**Title:** Heat Reclaim Isolation Relay i-Controller REV.112 Conversion

## Overview

*Figure 1. Isolation Relay Wiring*

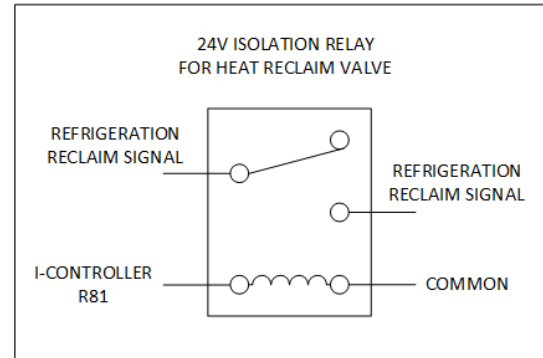
## Reclaim Isolation Relay

The isolation relay will be installed in the low-voltage section of the electrical cabinet.
